PINOLE-HERCULES

WATER POLLUTION CONTROL PLANT UPGRADE PROJECT

Peer Review of Pre-Design Documents

December 2013

Excerpt from Figure 8-13; PC3 (full size available in Appendix)

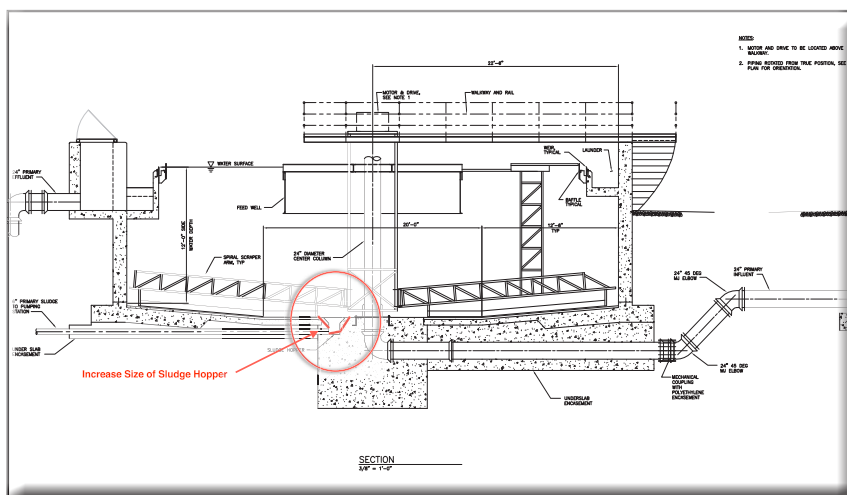
Recommendations to the Primary Clarifiers (PC)	
PC- 1	Build PC3 in Stage 2
PC- 2	Enlarge the sludge hopper for new PC3. Refer to <i>Figure 8-13</i> for detail.
PC- 3	Consider Stainless Steel over painted steel for the clarifier mechanism
PC- 4	All nuts and bolts should be stainless steel.
PC- 5	Add scum pumping to PC3 and route to digesters.

Recommendation PC- 2, enlarging PC3's sludge hopper will help better achieve the design and operational goal of thickening the sludge in the primary process. A larger hopper will also allow a more consistent rate of pumping sludge to the Solids Handling facility.

Excerpt from *Figure 14- 16 Retrofitted Effluent Pumping Station* (full size available in Appendix)

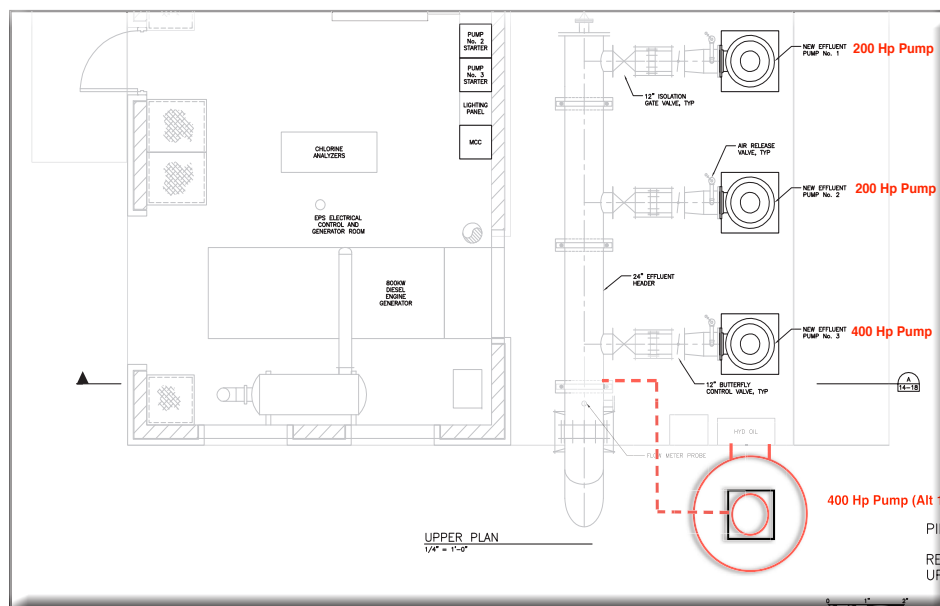
Recommendations to the Effluent Pumping (EP)	
EP- 1	Change three pump configuration from three 400Hp motors to one 200Hp motor and two 400Hp motors or two 200Hp motors and one 400Hp motor. Another option is to add an external steel can and fourth pump and then tee into the discharge header. This limits concrete deck mods and lowers energy demand for majority of operating conditions.
EP- 2	Need to add ability to add Caustic for pH control to offset the reduction in alkalinity caused by nitrification and maintain the effluent pH above that which could cause potential damage to the asbestos cement effluent pipeline.
EP- 3	Confirm that the final sampling point is located past the de-chlorination injection point.

Recommendation EP- 1 is an area that has large potential cost savings over a 20- year operational horizon. The pre-design requires the addition of three new 400-hp motors to pump anticipated wet weather flows while maintaining appropriate redundancy. The Review Team confirmed with WPCP Operations that it is very rare, in the current plant configuration to operate more than one 200Hp. Existing and predicted future minimum night flows are approximately 1.5 mgd, which with the new proposed 400Hp configuration has the high potential to operate on a start stop sequence. This is based on a review of the pump data, which shows that the 1.5 mgd is below the effective turn down rate of the new pumps. The Review Team recommends a minimum of one lower flow pump be maintained (and possibly two), which would handle approximately 90% of the pumping conditions. The third pump would be used during maximum wet weather flows. If there is concern with wet weather pumping redundancy, then the Review

Team recommends initially installing another 400 Hp pump in its own steel can connected to the existing wet well. The costs of the additional pump will be offset by the energy savings of using the smaller pumps during the vast majority of the year. See *Figure 14-16* for additional detail.

Excerpt from Figure 19 - 1 Yard Piping (full size available in Appendix)

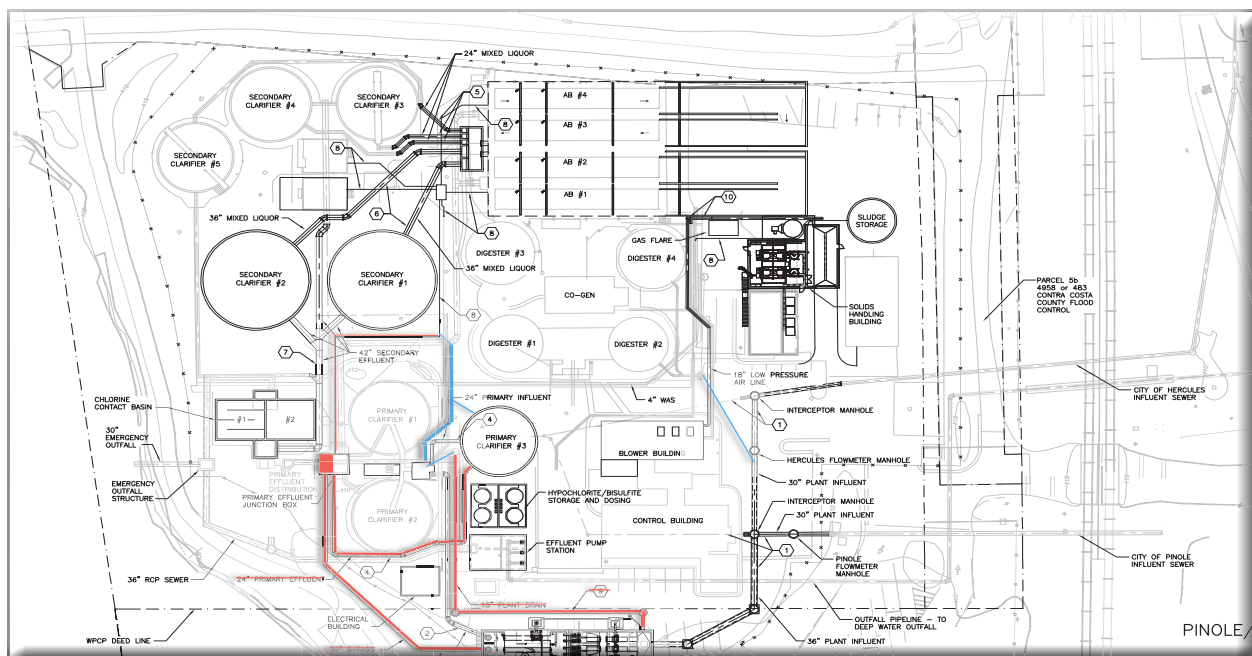
Recommendations to the Yard Piping (YP)	
YP- 1	Eliminate 30- inch diameter Bypass Piping from Headworks to Primary Effluent Box.
YP- 2	Re-route 24- inch diameter PC3 effluent pipeline from bypass structure to proposed new bypass pipe.
YP- 3	Reduce RAS feed line length and connect to new primary bypass pipe.
YP- 4	Re-route the effluent line from SC5 north of SC1 if the secondary effluent channel is constructed.
YP- 5	Route plant drain from solids handling area to new influent sewer line, downstream of Hercules meter.
YP- 6	Eliminate plant drain from existing discharge point (at existing influent wet well) to new Headworks. Instead, install a new wet well at the existing low point and pump discharge into primary clarifier feed distribution box.
YP- 7	Use PVC or HDPE for large diameter low head pipelines instead of steel, dip or rccp.

Recommendations YP- 1 and **YP- 2** were presented in the Headworks section on p.5 and p.6 of this document. If this concept can be incorporated, this will enable the existing bypass structure to be modified, demolishing the bypass side giving the Contractor more room to install the new Chlorine Contact piping/box channel connection. **Recommendation YP- 3** can be accommodated by routing the new RAS/WAS feed to the new bypass line, thus eliminating the pipe to the primary effluent junction structure. See attached marked up *Figure 19-1* for illustrative information.

FIGURE 5-5

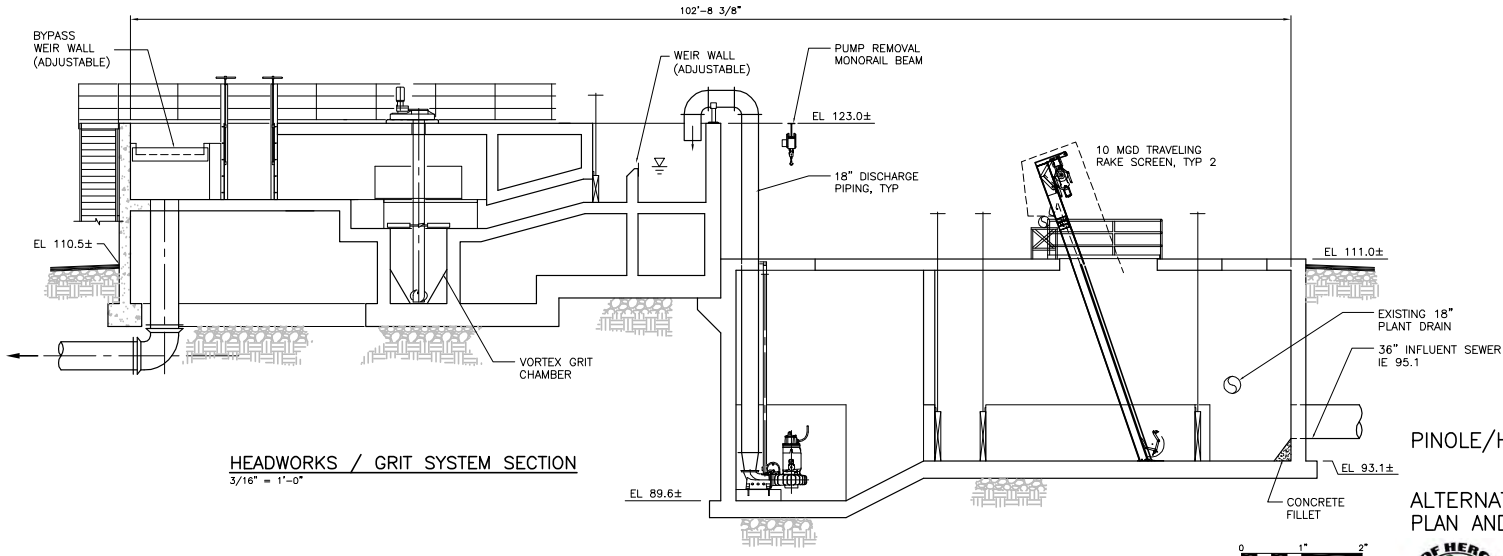
Recommendations to the Headworks (HW)	
HW- 1	Eliminate 30-inch diameter bypass pipeline and weir downstream of the influent pumps. Maintain bypass gate to isolate inlet of bypass channel from grit chamber feed.
HW- 2	To increase redundancy and reliability, offset screen location, allow discharge from the washer compactors to be individually conveyed to the screening dumpster.
HW- 3	Change orientation of grit tank to north side of the new Headworks Structure to improve access for Plant Staff and to keep construction confined within the current fence line.
HW- 4	Combine washer compactor screenings and grit into a single dumpster.
HW- 5	Reduce the number of bends in the grit system piping by adding an additional suction line and dedicated discharge from each pump to each cyclone.
HW- 6	Provide additional space for Ferrous/Ferric Tank next to the grit chamber (6,000 gallon).
HW- 7	Suggest roughing out the footprint for bio-filter. Due to space constraints, a similar odor control system as called for the solids handling may be required at Headworks.

The Review Team's primary recommendation for this area is **HW-1**, to eliminate the 30-inch diameter bypass weir and pipeline from the design. Instead of routing two 30-inch diameter pipelines from the Headworks Structure, the Review Team recommends that HDR consider designing one pipeline to the Primary Clarifier Splitter box and modify

the splitter box to handle the additional flow. The flow will then be routed through a new pipeline that connects with the existing Primary effluent pipeline, located southeast of new Secondary Clarifier No.1 (SC1). This re-routing will eliminate the new 30-inch diameter bypass piping, that is now shown to be installed outside of the plant fencing under the adjoining pedestrian pathway and PC3's effluent discharge pipeline, refer to attached *figure 5.5* for more detail.

Recommendations HW- 2 through HW- 5 focus on reconfiguring the grit system and equipment. Relocating all of the equipment to the north side of the new structure will provide better access for the WPCP's Operations and Maintenance Staff. The new location will also result in the installation of a conveyance system that can consolidate the rags and grit into a single container, covered with odor control ducting. Refer to attached *Figure 5.5* for more detail.
